12 February 2014

**RE Modification Request Cronulla Marina Tonkin Street, Cronulla
 MP06_0063 MOD1**

Relocation and Enlargement of the approved Floating Pontoon

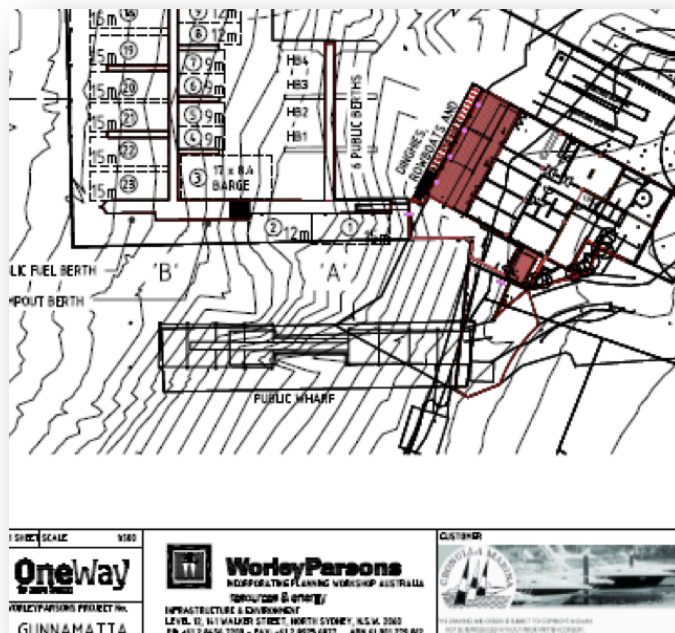
"The 35m long pontoon will be accessed from the dockyard by a ramp..."

Is there any way for the floating pontoon to be accessed by the public that arrive via the boat ramp? For example, should someone want to launch a kayak or similar small craft, would they have to first gain access to the dockyard? Would the public be welcome on the pontoon if it interfered with the commercial operations taking place?

It is not clear from studying the Section 75W Modification Request - Statement of Environmental Effects what has happened to the area where the floating pontoon is located in the existing approval. It is shown in some of the photomontages in the old location. It is also not clear what would be built where the pontoon is currently approved. The Section 75W Modification Request - Statement of Environmental

Effects Part 1 SITE ANALYSIS / ROOF PLAN drawing shows the area approved by Sutherland shire Council at RL 2.0 but the current approval for the slipway shows it as a pontoon (see Approved Site Plan extract above).

Figure 3-4 View of the northern boundary of slipway area with adjoining Council boat ramp in the foreground

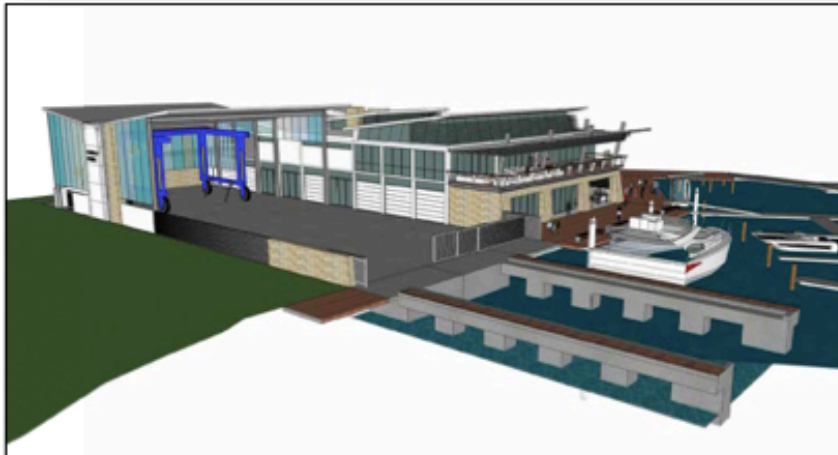
There is currently a sloping slipway. This slipway approximates the natural shore profile and does not have a large visual impact when viewed from the scenic head of Gunnamatta Bay. The travel lift arms extend a long way out and need to be level. They make a very large visual impact, especially at low tide when they may be up to 2 meters above the water.

With reference to the photograph below: note that the travel lift arms would commence beyond the bottom (water) end of the ramp and extend outwards. They would be close to 2m high (approximately the height of the two black piles) above the water level shown in this photograph. The fence/wall extends upwards from that level, creating a significant blank wall. Any raising of the dockyard floor will increase the negative visual impact of the site when viewed from the head of Gunnamatta Bay.

Figure 4-4 Northern photomontage view of the proposed development (Source: Innovative Architects)

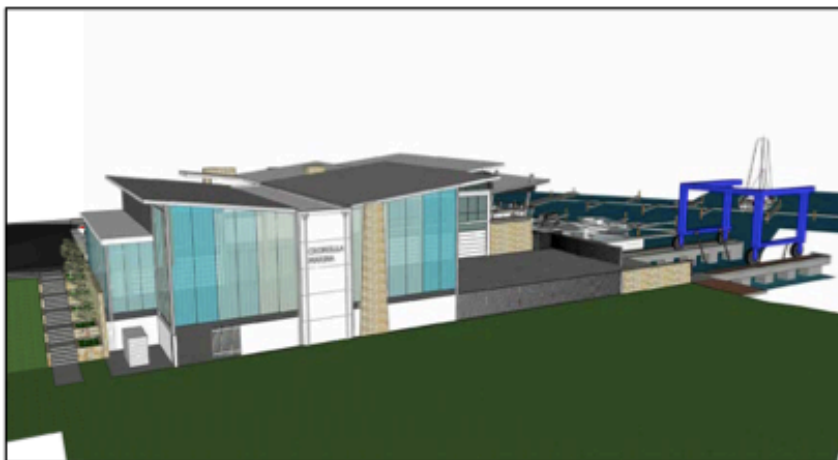
The photomontage above shows only a relatively low fence/wall along the northern boundary. If built as shown, there will be a considerable drop (up to approximately 2m) below the fence/wall to the natural shore below.

The existing slipway gradient is not dramatically different to the natural shore gradient, and therefore, does not present a large wall structure when viewed from the north.
